## Addendum No. 01

DATE June 20, 2016  
CLIENT Department of Veteran Affairs  
PROJECT Relocate Police Operation Center  
BWBR COMM. # 3.2015217.00

This Addendum modifies the Bidding Documents for the project identified above.

Drawing Title  
**FIRST FLOOR PLUMBING/SPRINKLER DEMOLITION PLAN**

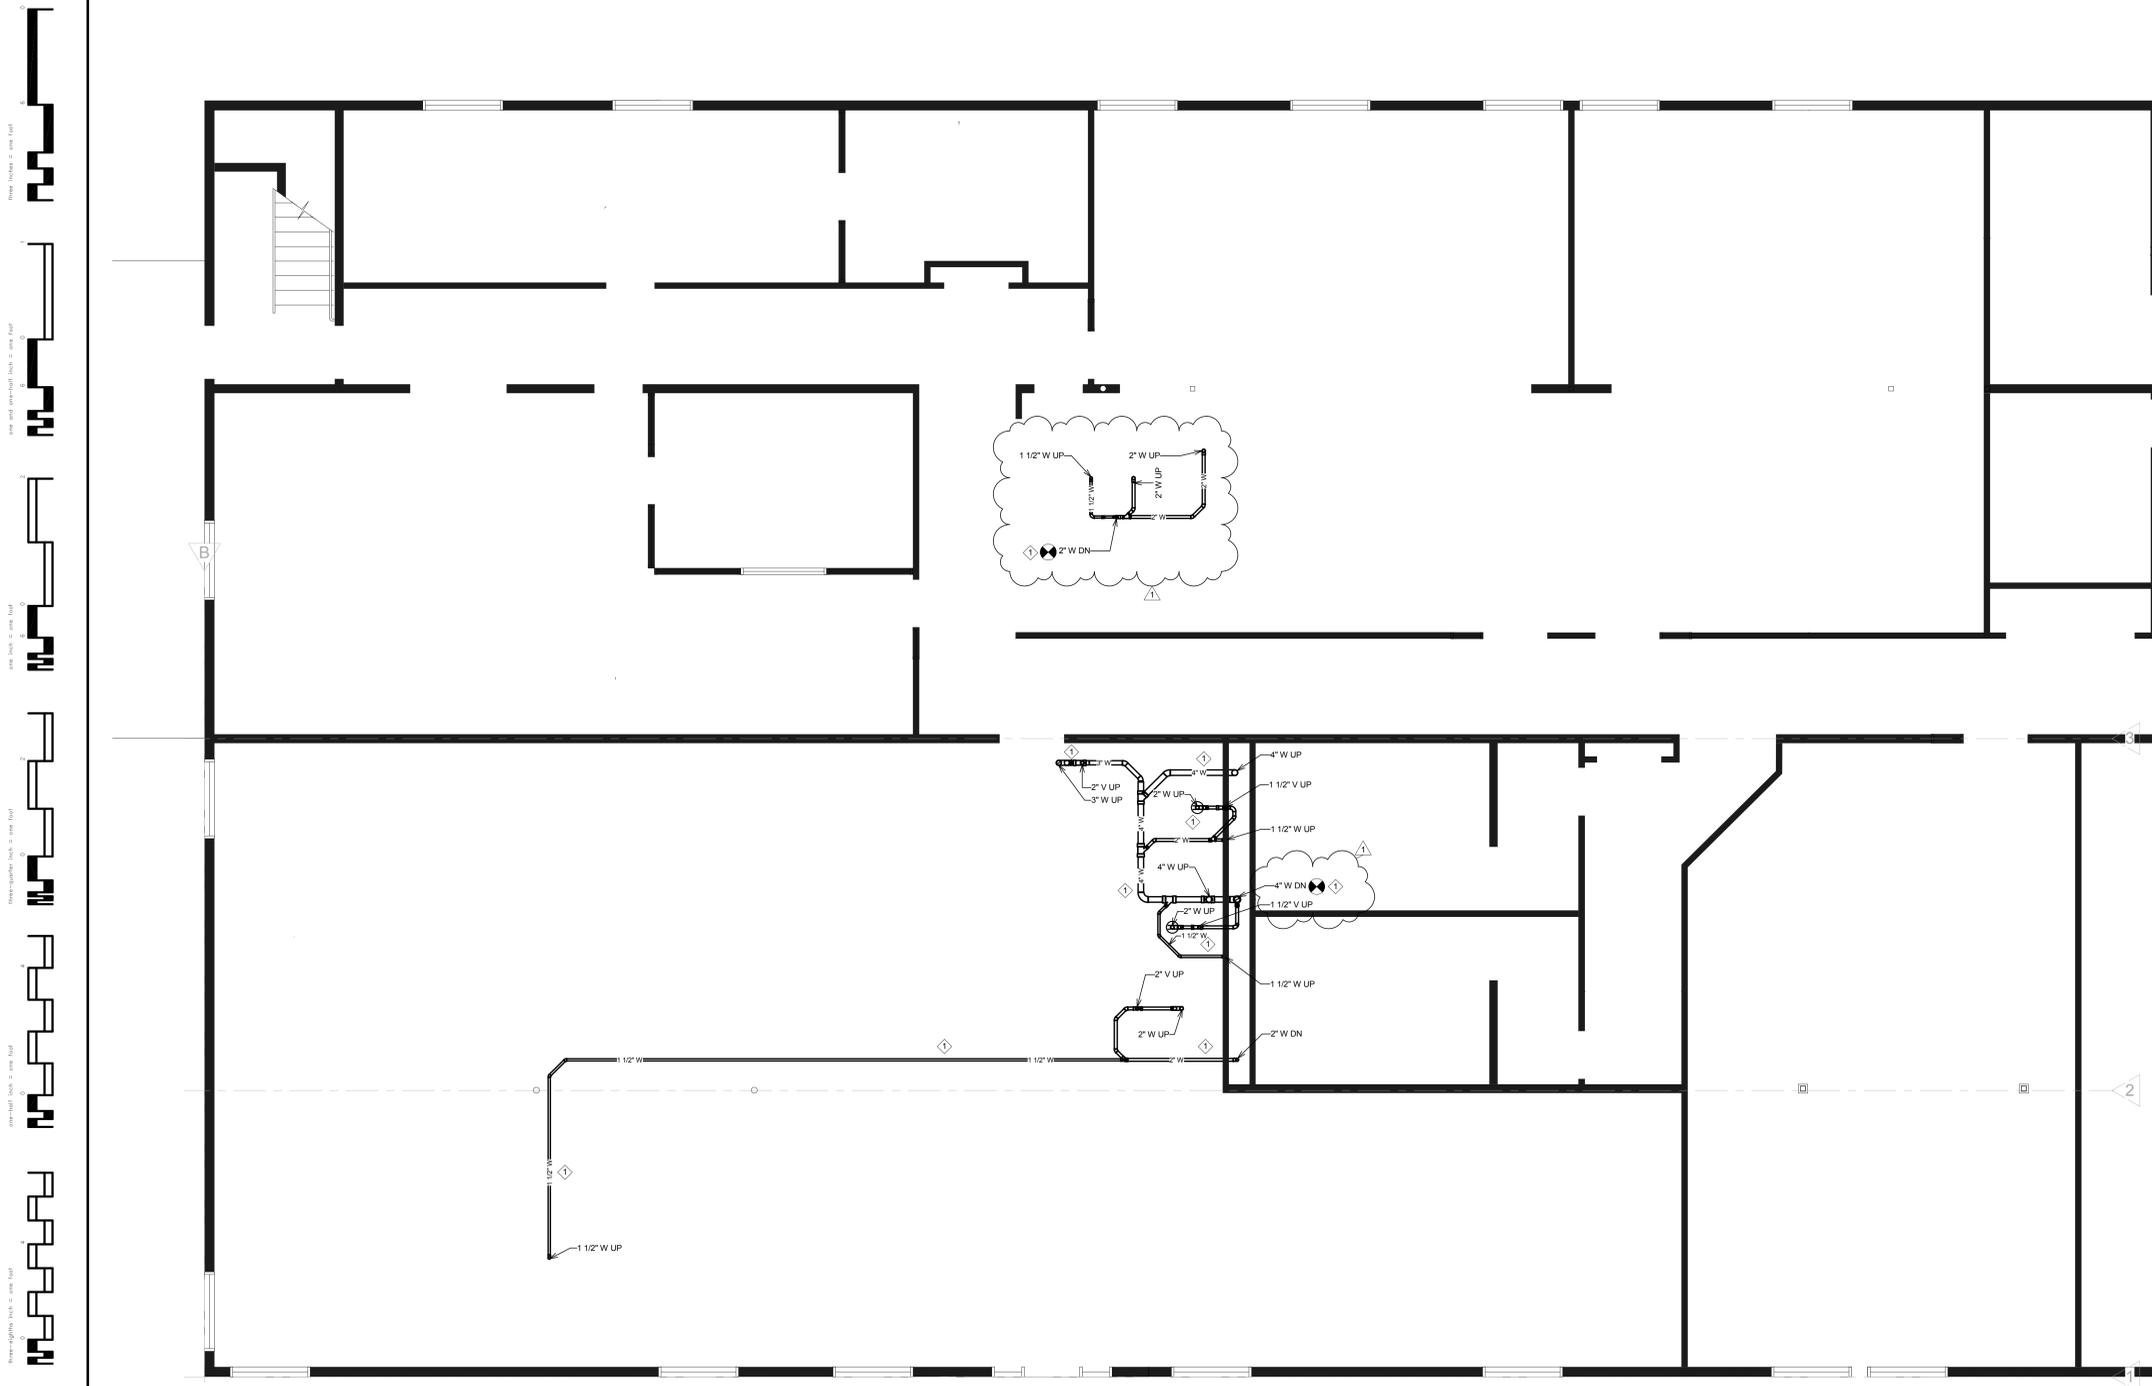
1. **MD103 – First Floor Plumbing/Sprinkler Demolition Plan (Reissued)**
  - A. Refer to attached drawings for demolition of existing dishwasher rough-in for relocation.

- ④ REMOVE EXISTING WASTE PIPING AND DOMESTIC WATER CONNECTION WITH BACKFLOW PREVENTION, TO EXISTING DISHWASHER REQUIRING TO BE RELOCATED. COORDINATE FLOOR SAWCUTTING AND PATCHING REQUIRED TO RELOCATE THESE SERVICES TO NEW ROUGH-IN LOCATION AS REQUIRED.

Drawing Title  
**UNDERGROUND PLUMBING PLAN**

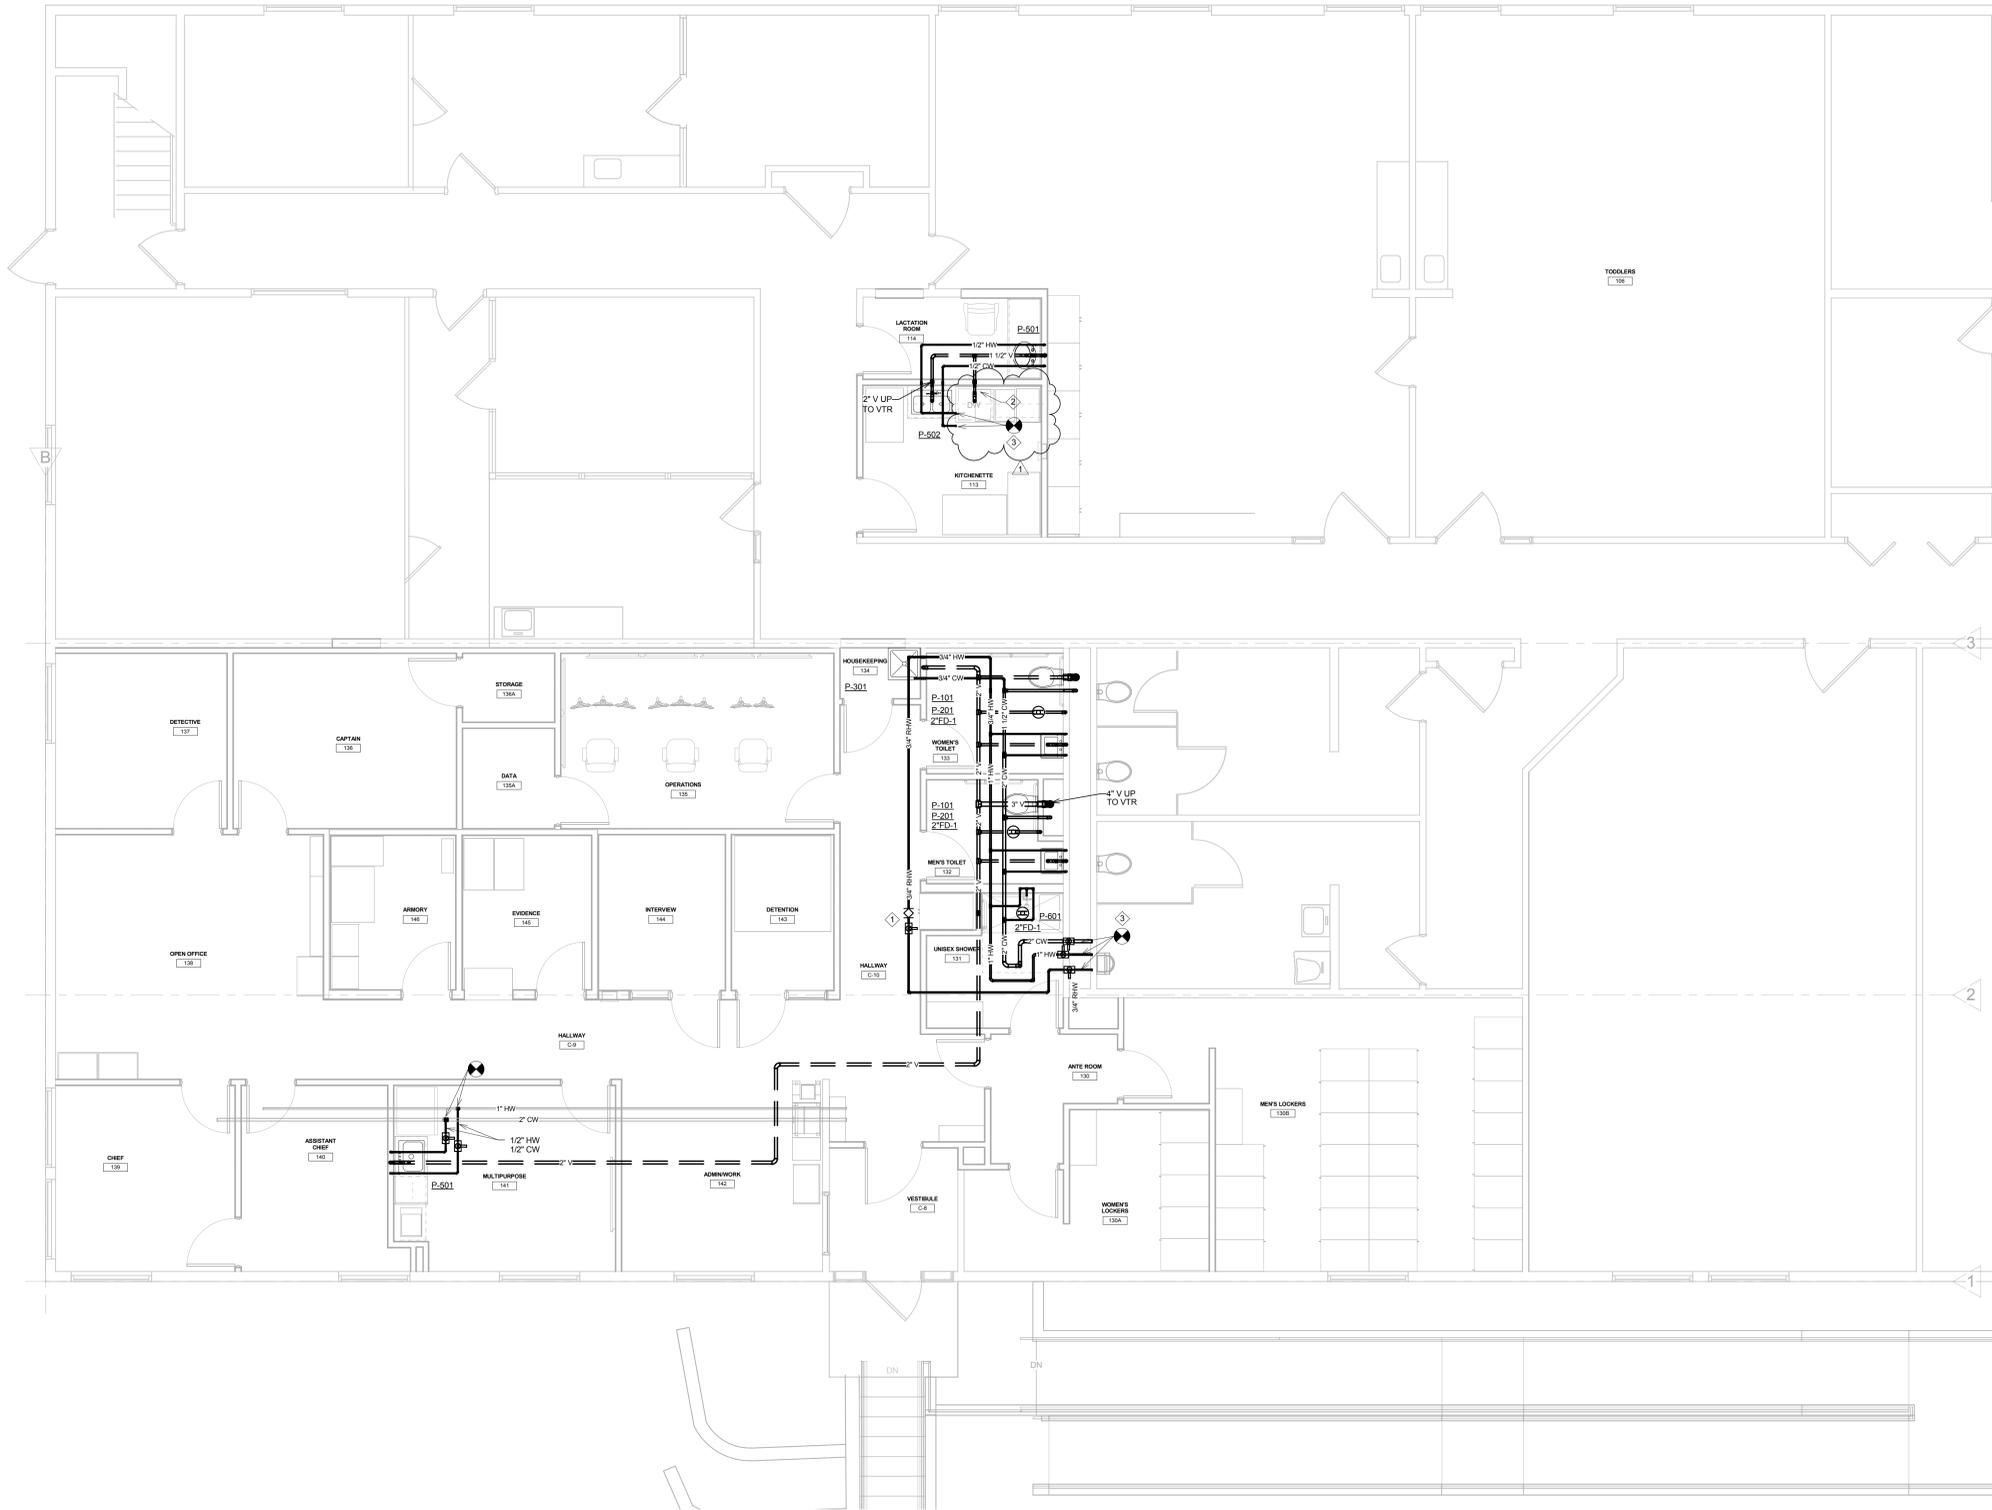
2. **PP100 - Underground Plumbing Plan (Reissued)**
  - A. Refer to attached drawing for installation of standpipe drain for dishwasher and clarification for connection of piping to existing services.
